C2032x MAIN FIRMWARE RELEASE NOTES

Uni-7 Series with PK-260B CPU Board

C2032x supersedes B0779x as the standard Uni-7 firmware for the revised PK-260B CPU board.

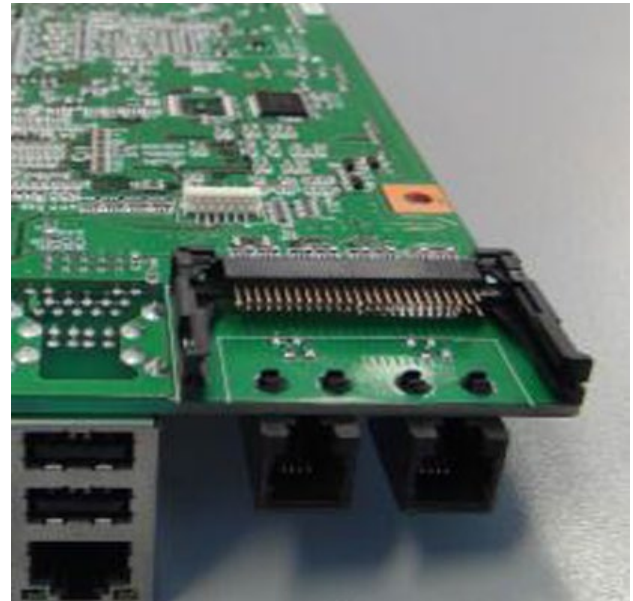
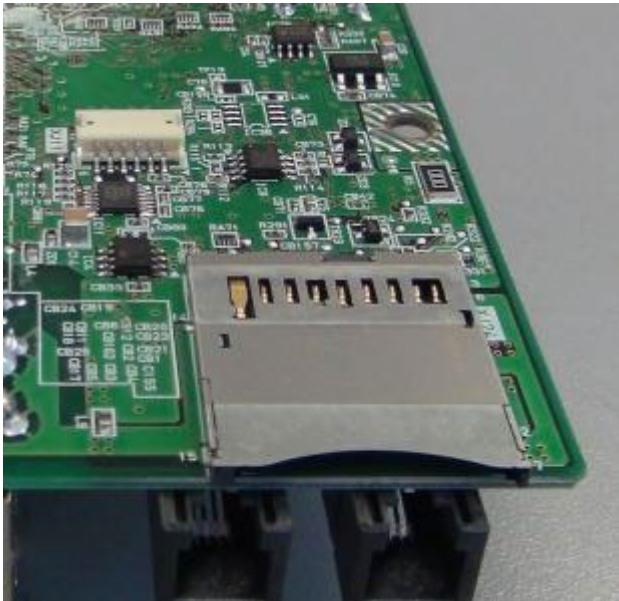
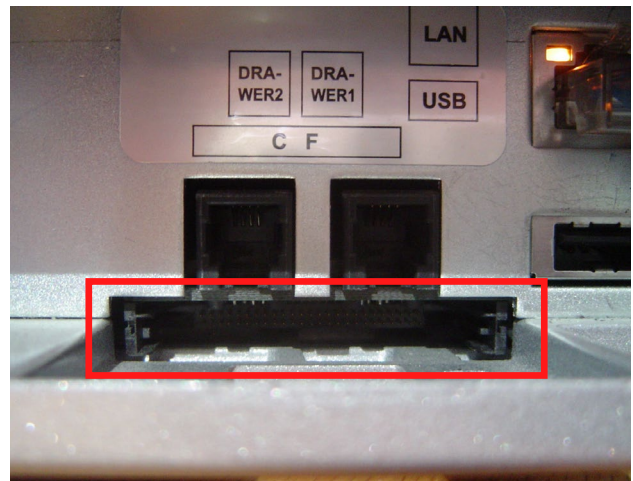
Firmware C2032x is designed for the revised CPU board PK-260B. **This firmware is not compatible with the previous CPU board PK-260A.** And previous firmware (B0674x, C1991x, etc.) is not compatible with the new PK-260B CPU board.

The two CPU board versions can be easily identified by the expansion memory card slot located on the left side of the Uni-7. See the images below.
